RE: Response to IDNR Letter dated January 24, 2025 (Doc #111960)
Conceptual Development Plan
Marshall County Sanitary Landfill
Permit No. 64-SDP-02-75P

This letter contains responses and information requested in the January 24, 2025 IDNR letter related to IDNR review of the Conceptual Development Plan (CDP, Doc #111541) for the Marshall County SLF. Our responses are formatted according to the numbered items in the referenced letter (Doc #111960).

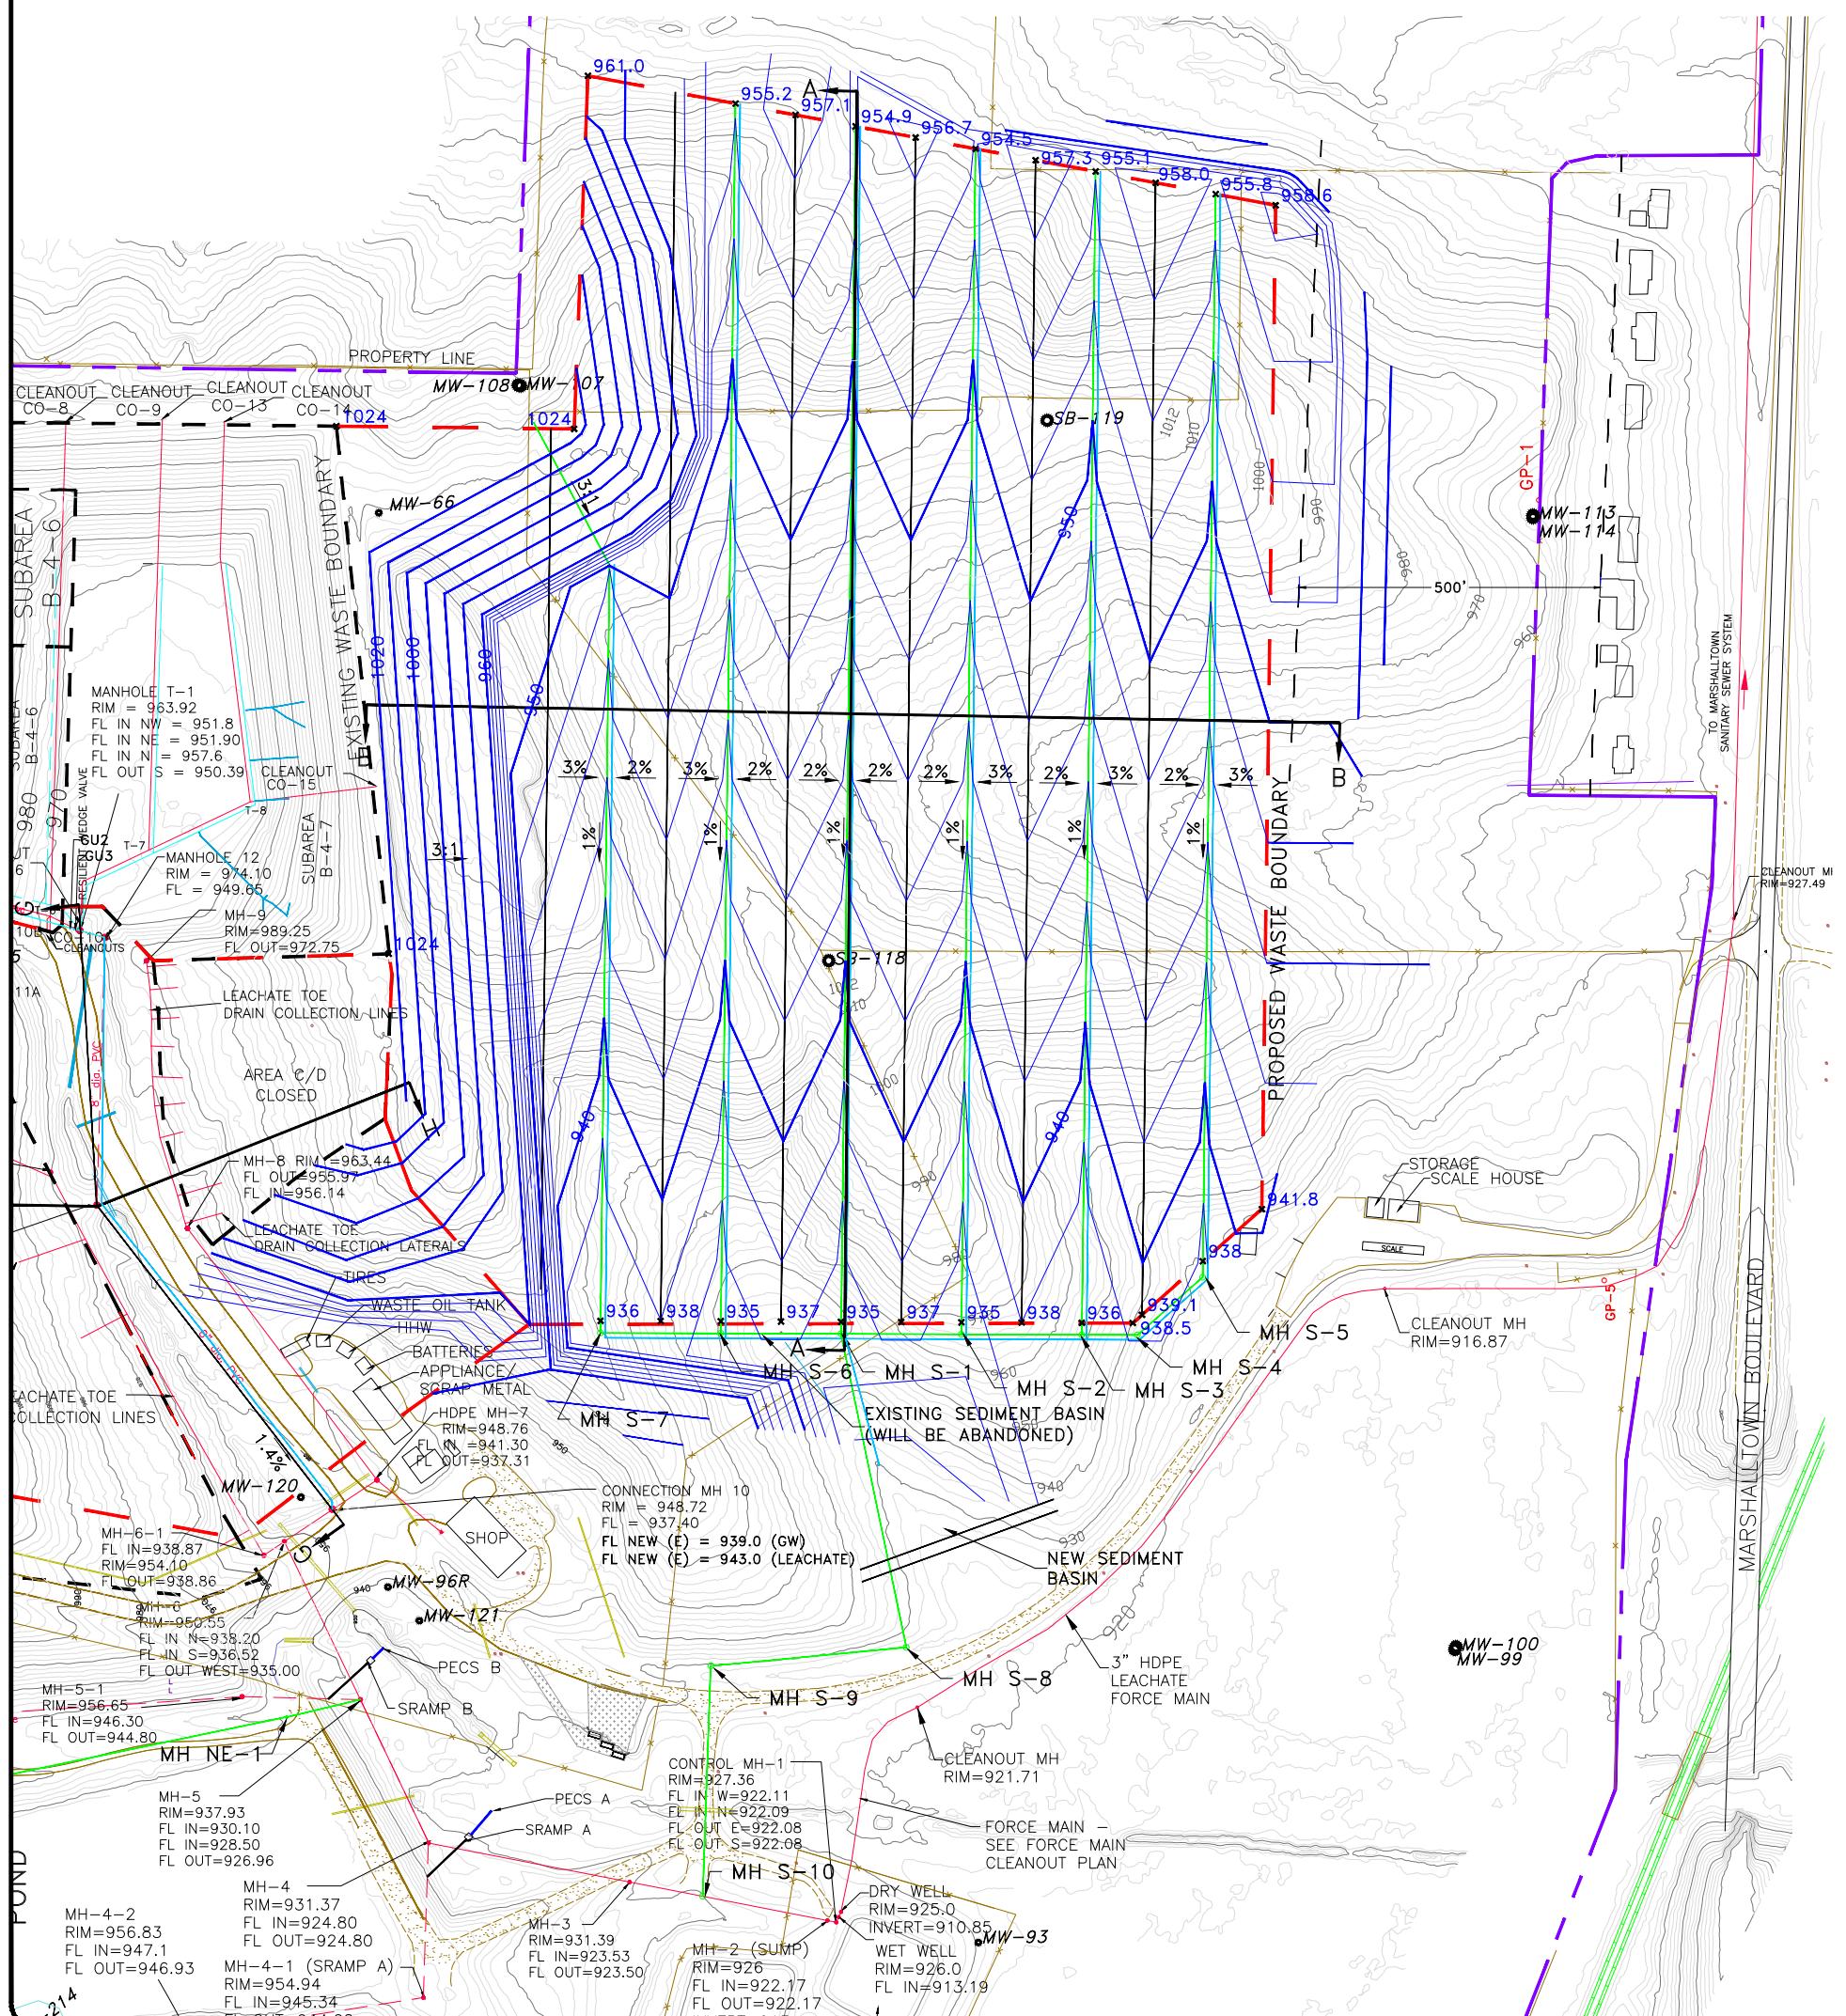
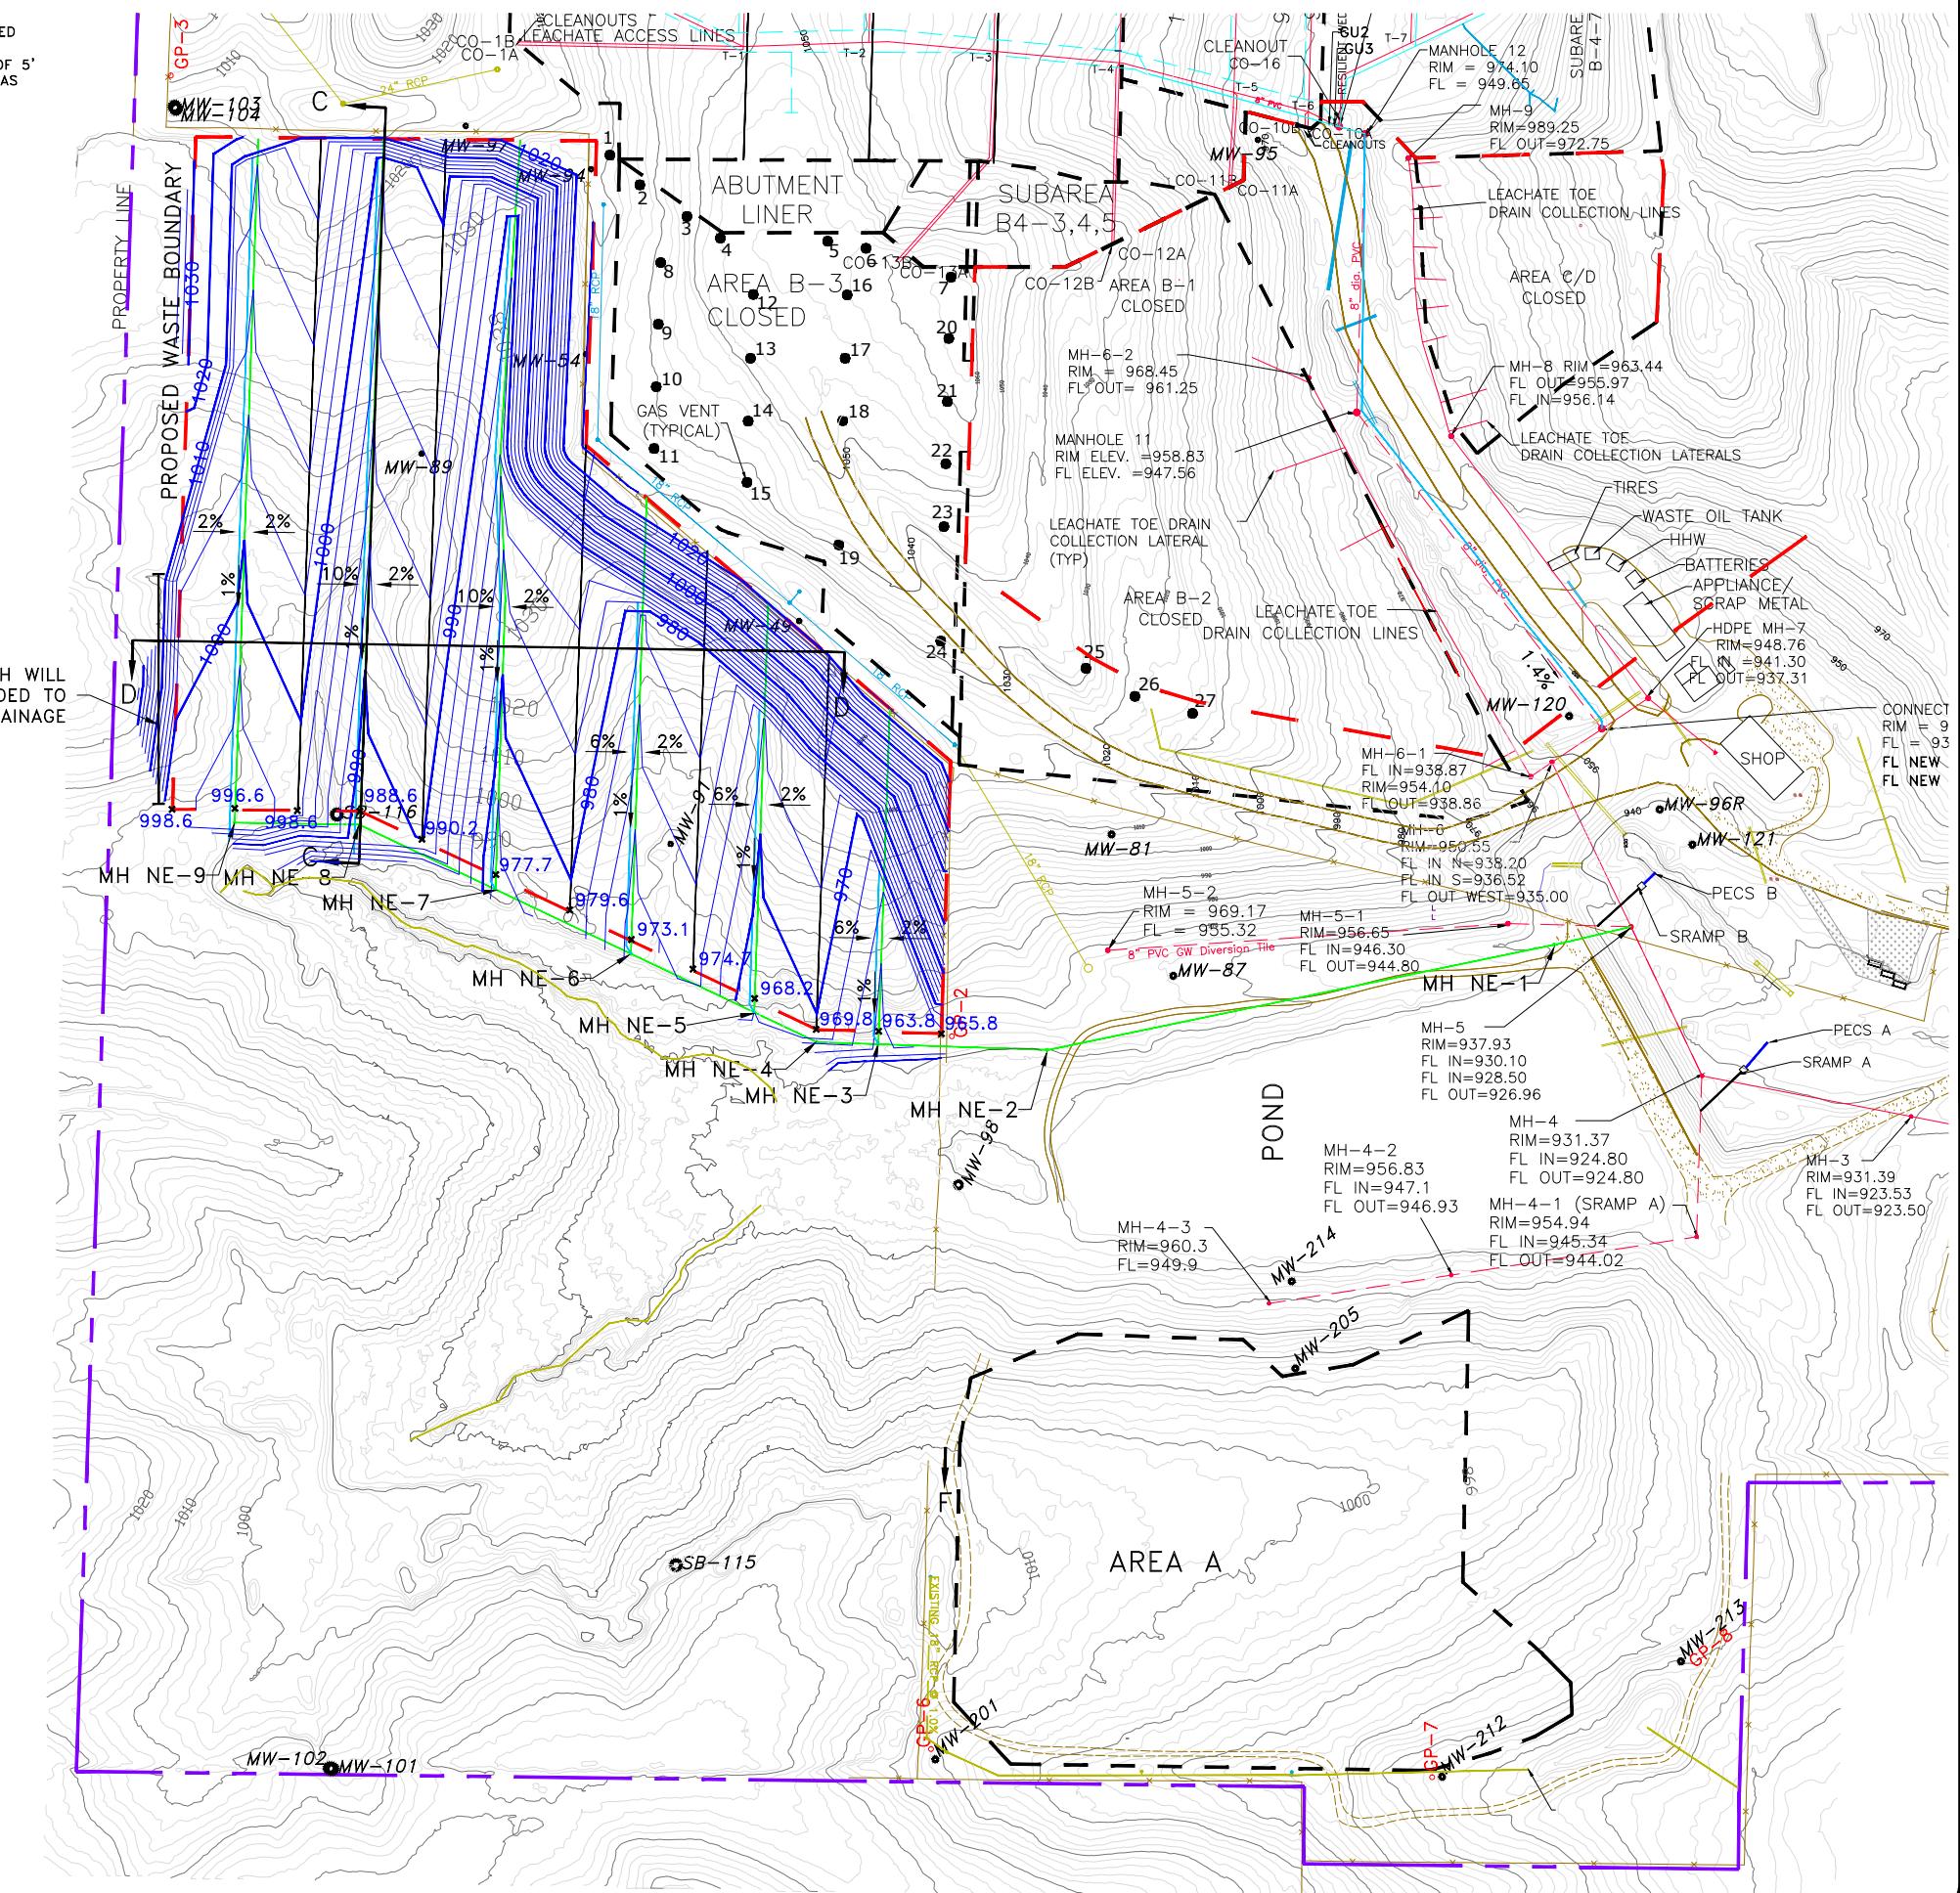
Groundwater diversion piping will be installed on the base of the future disposal areas parallel to the leachate collection piping. The proposed location of the groundwater diversion piping in each

area is shown on revised Figures 6, 7 (South Development Plan), 10 (North Development Plan), and 15 (Mid Area Development Plan) in Attachment A.

The elevations of the manholes and leachate conveyance piping for the North Development Area (except for MH NE-8 and MH NE-9) have been lowered by approximately 6' from the elevations shown in the CDP to allow the groundwater collected in the attenuation zone shown in the "2019 Amendment #1 to the 2017 Assessment of Corrective Measures Report" (Doc #95276) to either be routed to the leachate collection system and conveyed to the leachate storage lagoons (as shown on Figure10) or, if future testing warrants, to be discharged to the surface. MH NE-8 and MH NE-9 were not lowered as the groundwater collected in areas that drain to these manholes is outside of the attenuation zone. Construction in the North Development Area will proceed from south to north so these two manholes could be modified prior to construction to allow the groundwater piping to be connected to the leachate collection system at these manholes if deemed necessary by future water quality testing.
